Access Compliance Report

Public Rights-of-Way

Intersection ID: 32112	Main Street: ADISON_GRAY_LN	Cross Street: COUNTRY_LN	Location: SW
ADA ID: 8F0F755FF0F9	Ramp Type: BlendTrans1	Initial Pass/Fail: Fail	Overall Compliance: No
		Severity Score: 10

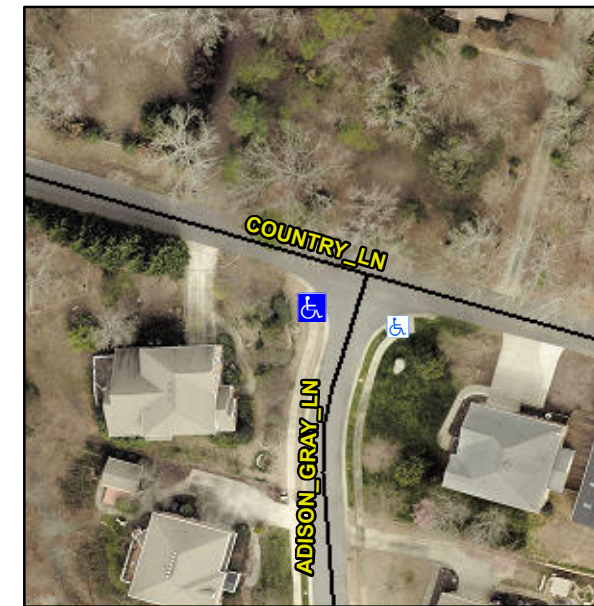
R304.5.1, R304.5.3

Compliance	Description	Data	Compliance	Description	Data
N/A	Ramp Length (in)	49.0	Yes	BlendTrans Slope (%)	0.2
No	Ramp Width (in)	44.0	No	BlendTrans XSlope (%)	2.5
N/A	Flare Type LT	N/A	N/A	Flare Type RT	N/A
N/A	Flare Slope LT (%)	N/A	N/A	Flare Slope RT (%)	N/A
N/A	Flare Traversable LT?	N/A	N/A	Flare Traversable RT?	N/A
N/A	Landing Length (in)	N/A	N/A	DWS Provided?	N/A
N/A	Landing Width (in)	N/A	N/A	DWS Contrast?	N/A
N/A	Landing Slope (%)	N/A	N/A	DWS Length (in)	N/A
N/A	Landing X Slope (%)	N/A	N/A	DWS Full Width?	N/A
N/A	Landing Curb? (Y/N)	N/A	N/A	DWS Offset (in)	N/A
N/A	Shared Landing?	N/A			
N/A	Gutter Ponding?	N/A	N/A	Gutter Slope (%)	N/A
N/A	Gutter Lip Ht (in)	N/A	N/A	Gutter X Slope (%)	N/A
N/A	Painted X Walk1?	No	N/A	Painted X Walk2?	N/A
	X Walk 1 Direction	To E		X Walk 2 Direction	N/A
	X Walk 1 Width (in)	N/A		X Walk 2 Width (in)	N/A
	X Walk 1 Slope (%)	9.0		X Walk 2 Slope (%)	N/A
	X Walk 1 X Slope (%)	7.1		X Walk 2 X Slope (%)	N/A

Remove & Replace Curb Ramp With Two New Directional Ramps or Equivalent.
